DEPARTMENT OF TRANSPORTATION

Quality Assurance and Source Inspection

Contract #: 04-0120F4Cty: SF/ALA Rte: 80 PM: 13.2/13.9File #: 69.28**WELDING INSPECTION REPORT****Resident Engineer:** Pursell, Gary**Address:** 333 Burma Road**City:** Oakland, CA 94607**Report No:** WIR-001294**Date Inspected:** 15-Jan-2008**Project Name:** SAS Superstructure**OSM Arrival Time:** 1930**Prime Contractor:** American Bridge/Fluor Enterprises, a JV**OSM Departure Time:** 730**Contractor:** Zhenhua Port Machinery Company, Ltd (ZPMC), Changxing Island **Location:** Shanghai, China**CWI Name:** Ye Yongjun**CWI Present:** Yes No**Inspected CWI report:** Yes No N/A**Rod Oven in Use:** Yes No N/A**Electrode to specification:** Yes No N/A**Weld Procedures Followed:** Yes No N/A**Qualified Welders:** Yes No N/A**Verified Joint Fit-up:** Yes No N/A**Approved Drawings:** Yes No N/A**Approved WPS:** Yes No N/A**Delayed / Cancelled:** Yes No N/A**Bridge No:** 34-0006**Component:** Caltrans Mock-Up**Summary of Items Observed:**

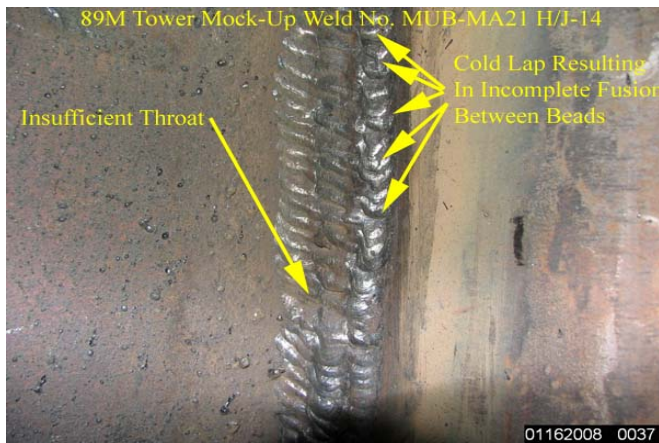
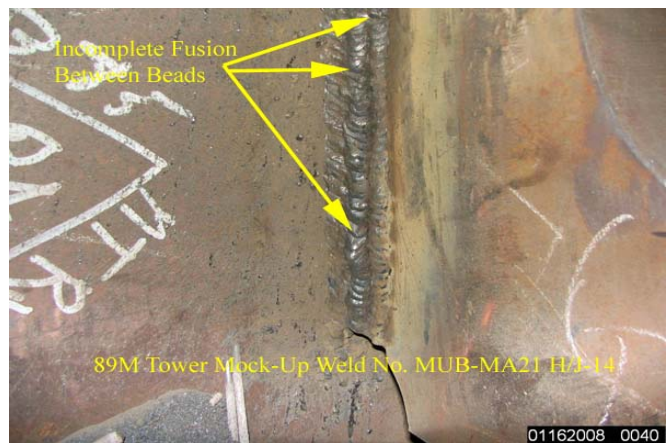
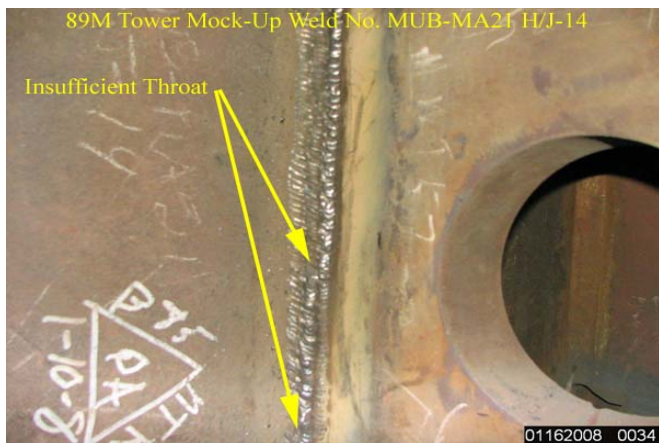
The Caltrans Inspector observed the completed Weld No. MUB-MA21 H/J-14 on the 89M Tower Mock-Up. It was observed that ZPMC CWI, Ye Yongjun (AWS CWI No. 07031461) had apparently visually accepted this weld. The QA Inspector observed that this weld is visually unacceptable in accordance with AWS D1.5-2002, paragraph 3.6 and Figure 3.3 due to insufficient throat and incomplete fusion between weld beads. See attached pictures.

These observations do not appear to meet the requirements of the job specifications.
